SPARANO + MOONEY ARCHITECTURE

ADDENDUM #2

PROJECT:	Caine Lyric Theatre – Fly Loft and Stage Improvements Project	PROJECT NO.	C001541
OWNER:	Utah State University 6550 Old Main Hill Logan, UT 84322-6605	Phone: 435.797.3771 Contact: Thomas Graham	
ARCHITECT:	Sparano + Mooney Architecture 57 West 2100 S Salt Lake City, Utah 84115	Phone: 801.746.0234 Contact: Seth Striefel	
DATE OF ISSUANCE:	April 16, 2025

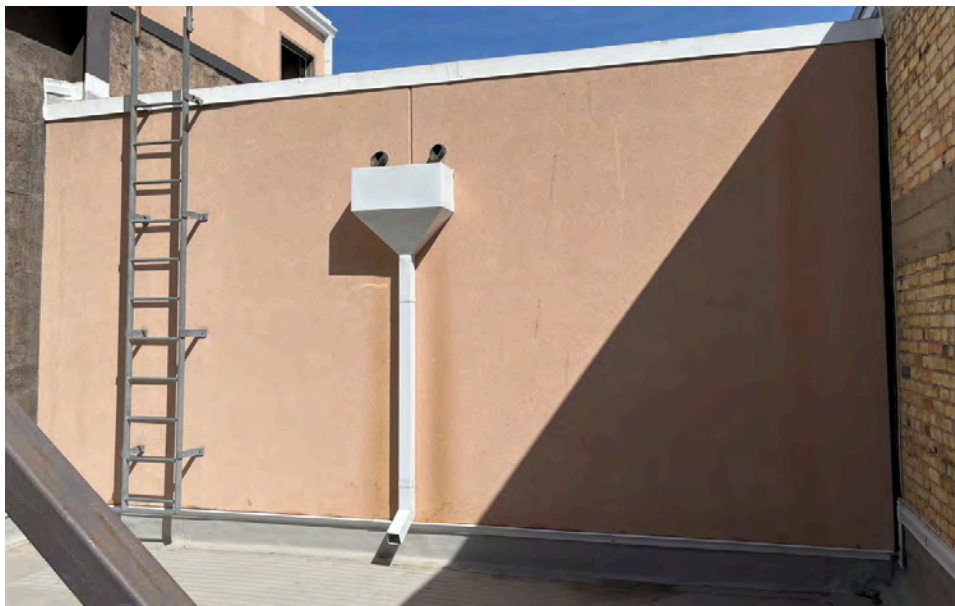
1. R Phillips proposes the following expansion joint layout highlighted below in green. Please verify and confirm this layout is acceptable.

Response: For bidding purposes, the layout is acceptable. Final layout can be determined during the submittal phase of the project and we may be able to reduce the number of control joints per standards.

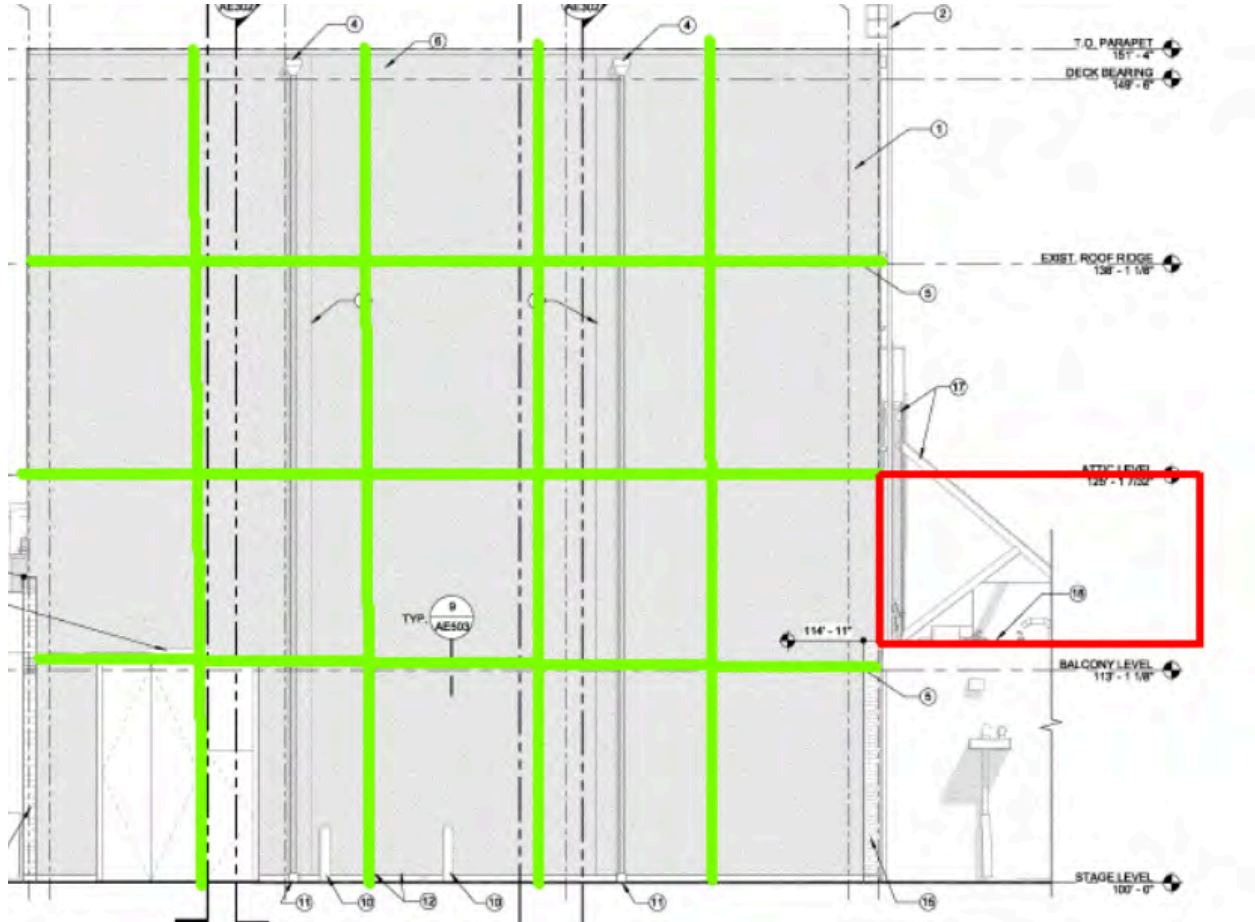
2. The highlight area in red is an EIFS wall on the south elevation. The drawings do not indicate a re-coat of this area. Please provide direction for this area. Is it going to receive a re-coat or not?

Response: Yes, this area should receive a recoat.

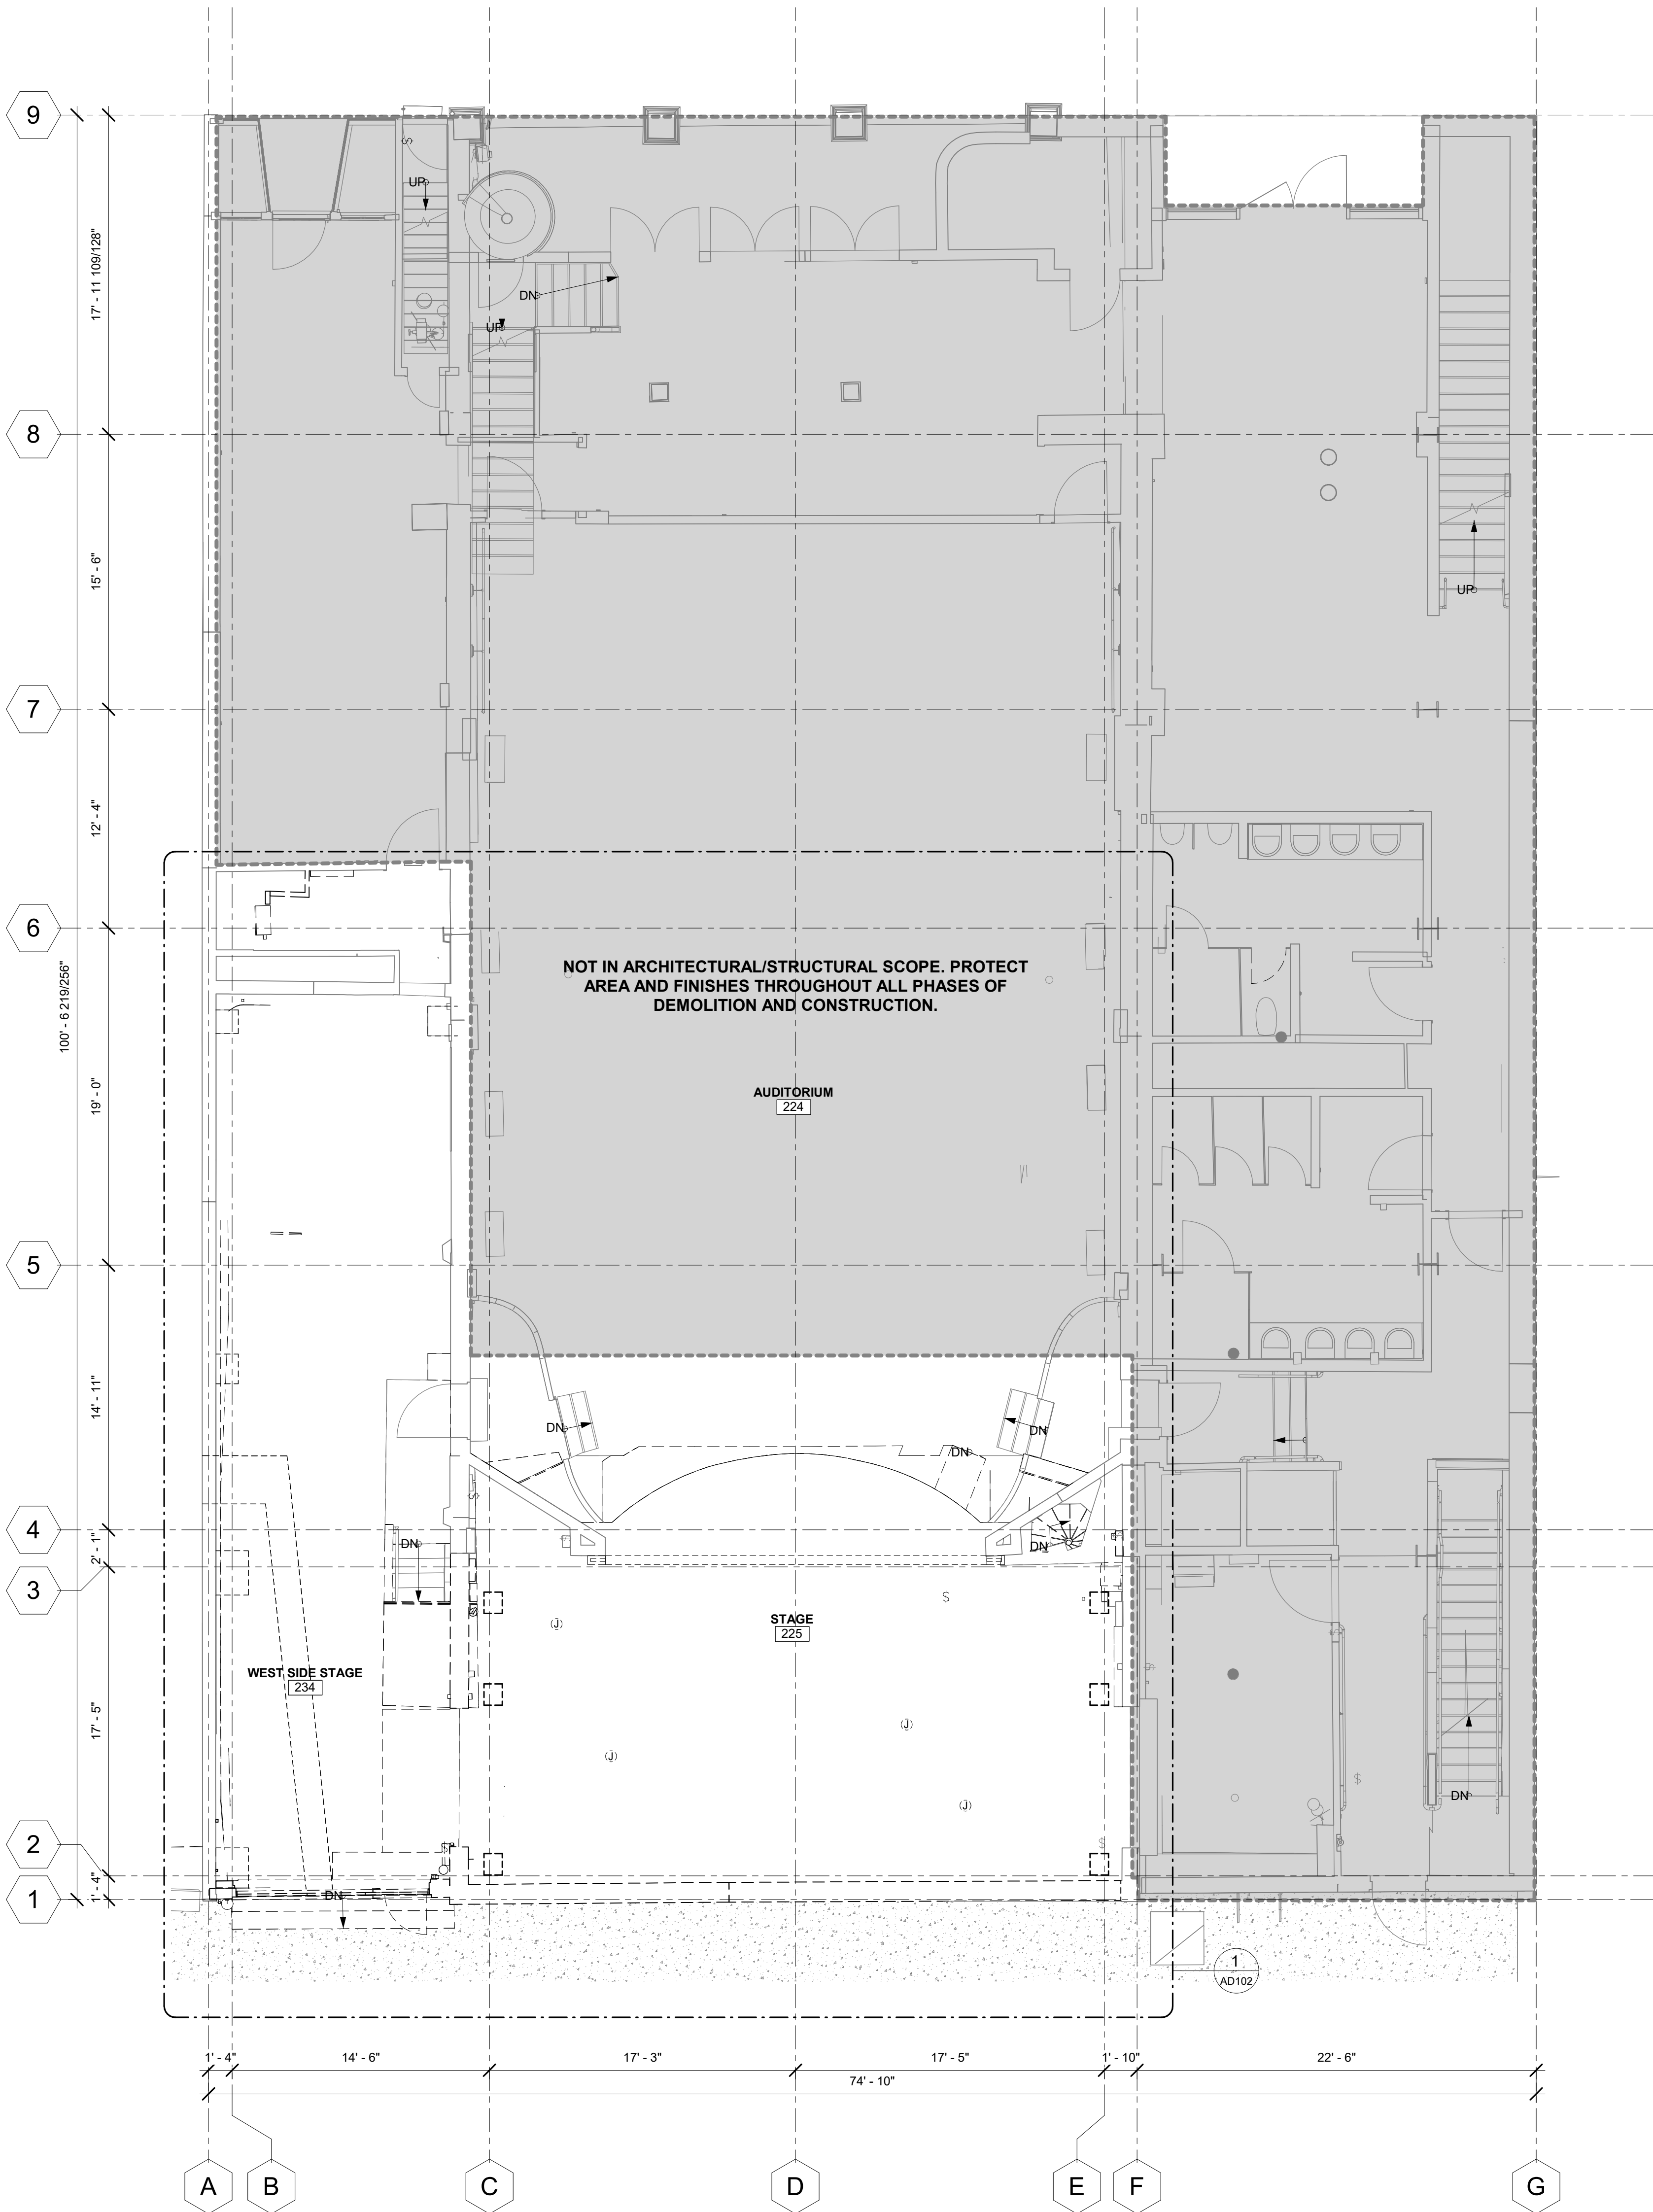
3. Upon inspection of the existing stucco/EIFS there are several areas that are in need of repairs prior to the re-coat. Is the intent to fix and repair prior to the re-coat or simply apply a new color coat?

Response: Yes, repairs of damaged stucco/EIFS and abandoned penetrations should be done prior to the recoat.

DEMOLITION STAGE LEVEL
FLOOR PLAN AND
ENLARGED PLAN

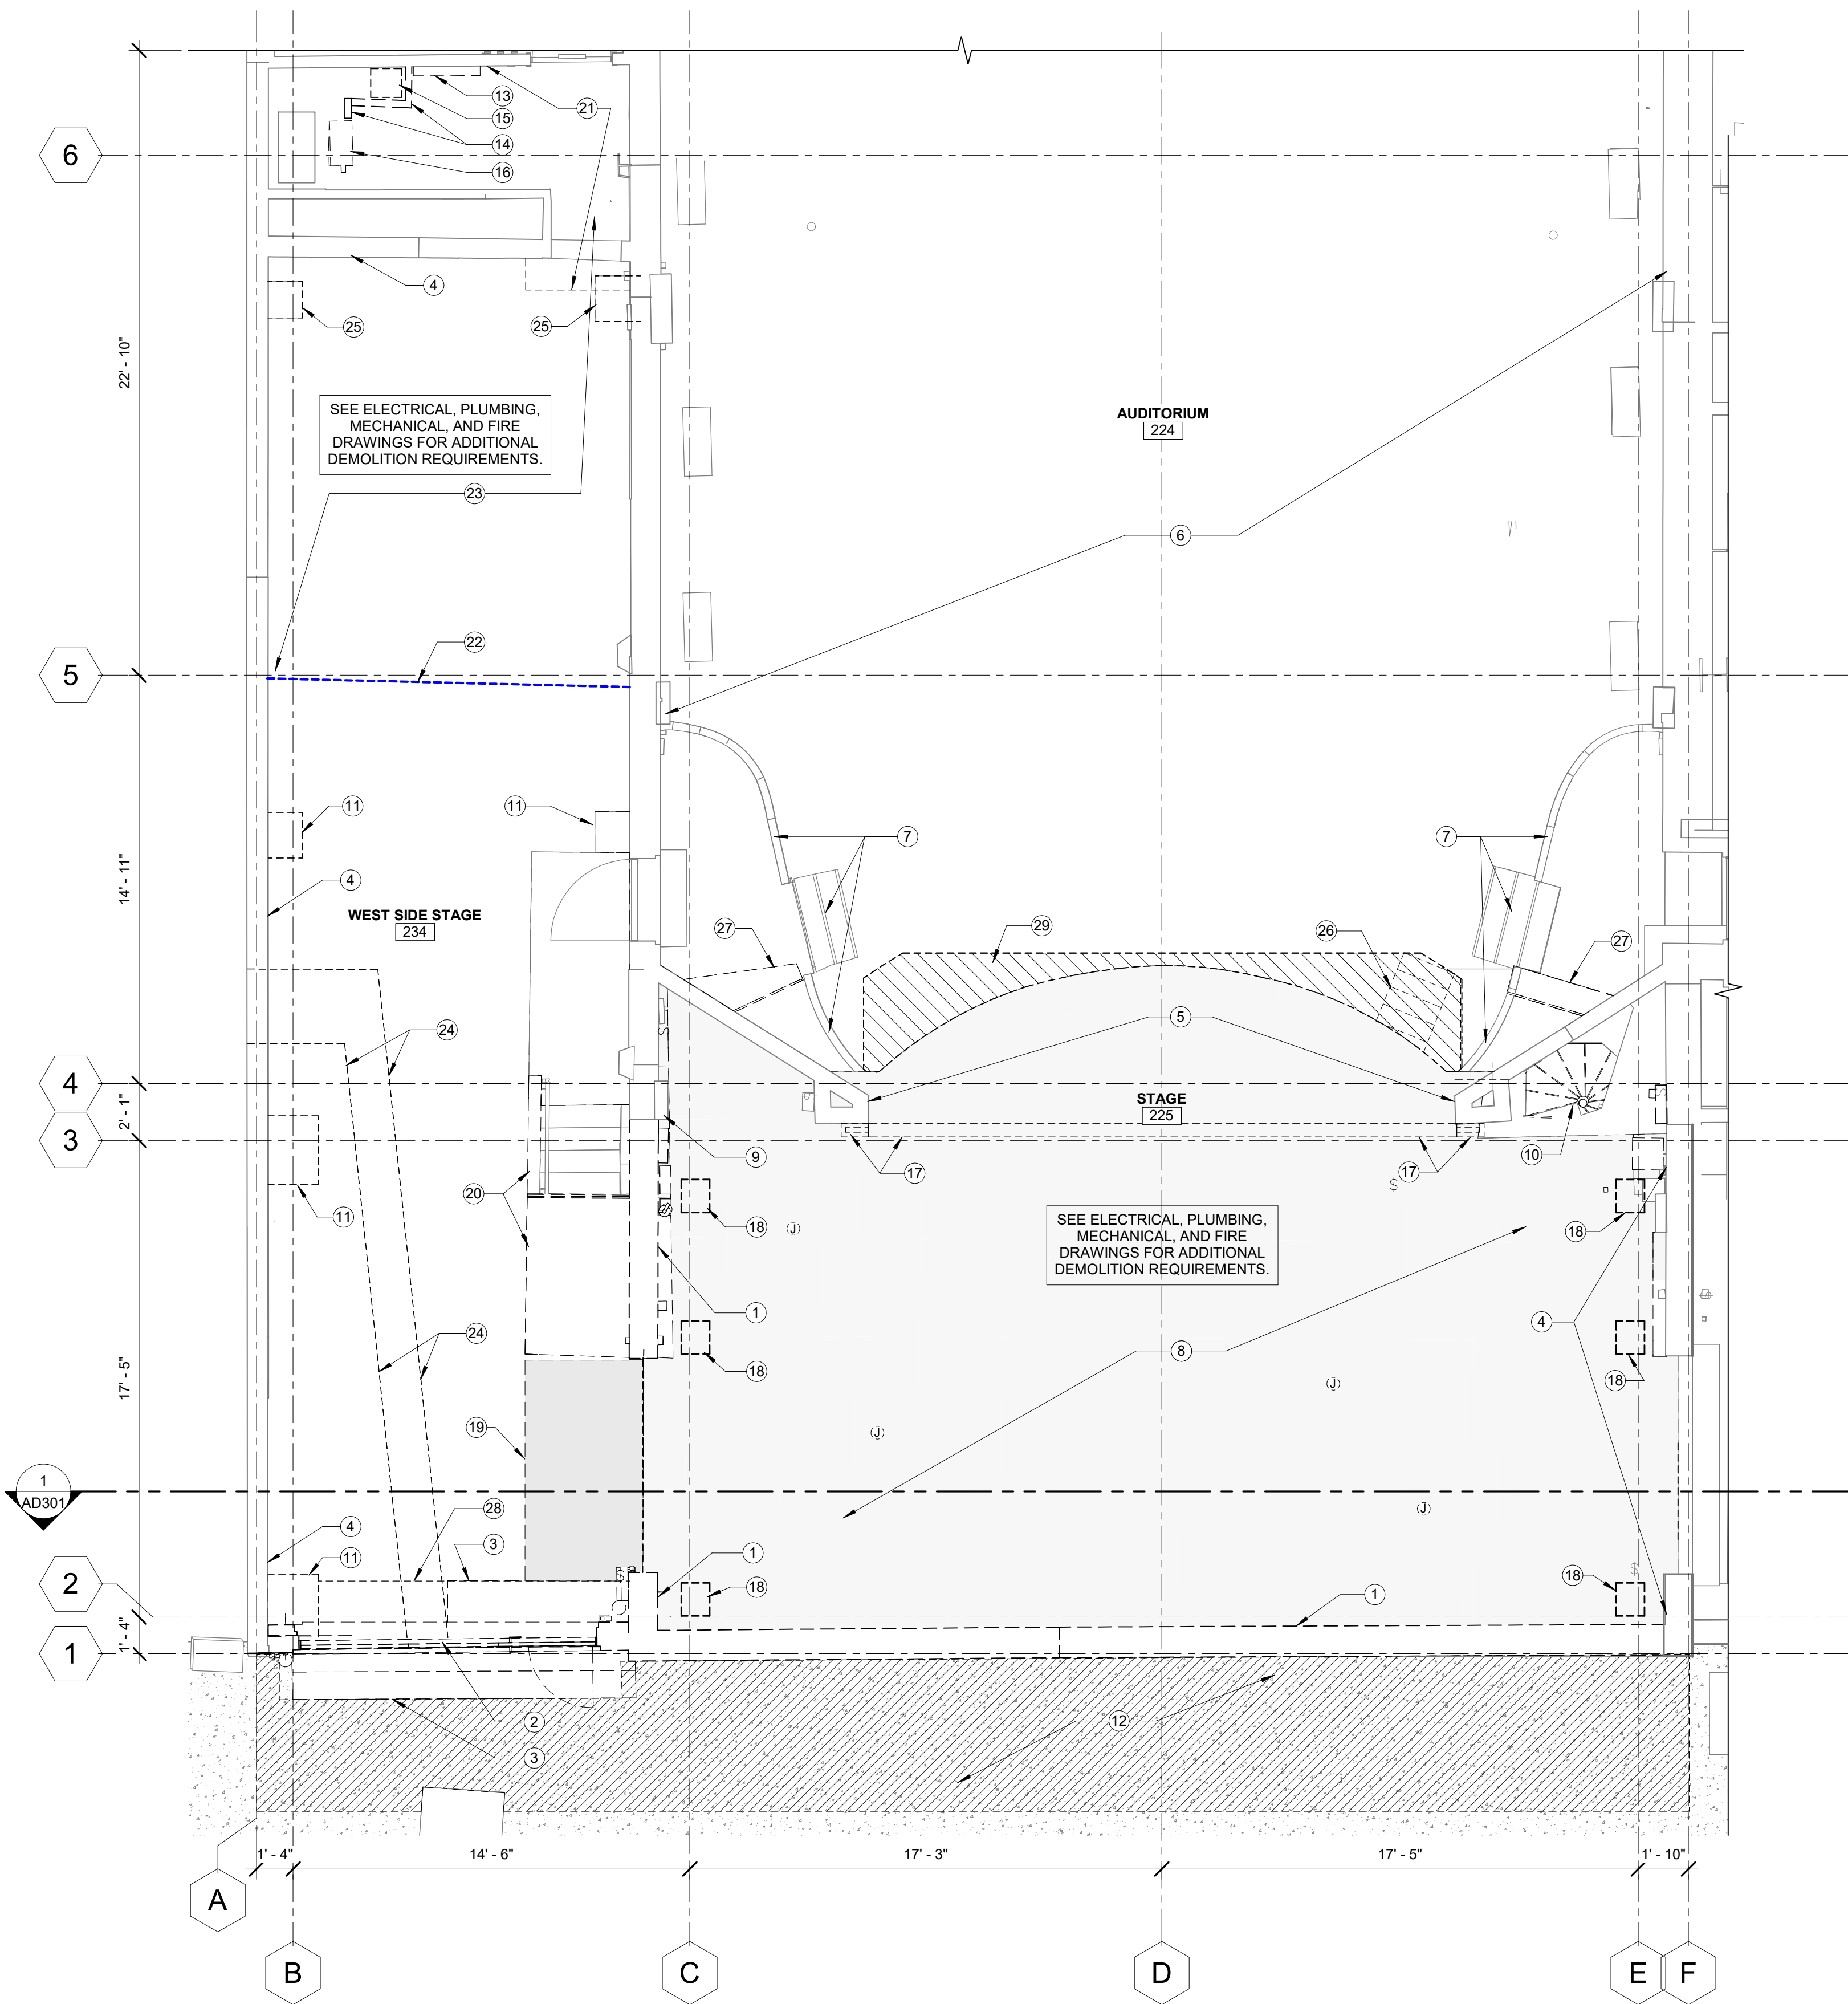
Since the issuing of the Construction Documents further testing of the existing fire curtain has been completed showing asbestos as not detected in the existing fire curtain. See attached Fire Curtain Asbestos Survey from Dixon Information Inc. dated 3/17/2025. Fire curtain and associated track and structure is to be demolished by the contractor per the revised attached demolition drawing sheet.
